DUNE ND I&I Assessment Report - 7/23/24

1. Charge

An internal review of the DUNE Near Detector installation plans was conducted during the first months of 2024. The main goal of this review was to evaluate the installation sequence, timeline and resources to ensure our estimates for ND installation are accurate. The details of the charge can be found [here](#). The review was held at FNAL on February 15-16, 2024 with Subject Matter Experts (SMEs) who have experience with the installation of similar underground detectors at FermiLab. The agenda and links to the presentation can be found [here](#). Recommendations from the subject matter experts were implemented during the months following the review.

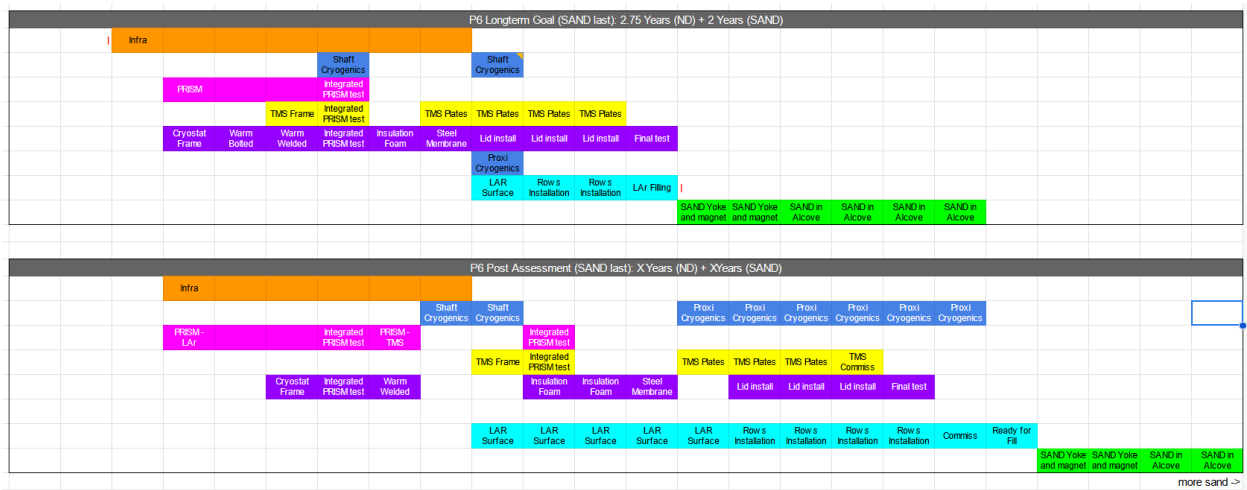
The overall duration of the Near Detector Installation is about 3 years and 9 months (as of 7/23/24). The graphics below show the previous and new 30,000ft view. The key difference is that the Shaft Cryogenics (blue block) and TMS (yellow blocks) used to be entirely in parallel with the Cryostat activities (purple block). We can now see the interruptions in the Cryostat activities to facilitate these activities. This schedule is longer but much more robust (less risks of cascade delays).

The 30,000 foot installation was presented to the SME. The new 30,000 ft view shows the alternance of activities between TMS and ND-LAR which enables parallel activities, and provides flexibility to adjust the schedule in case one of the detector installations gets delayed (if one detector gets delayed, we can continue installation on the other one).
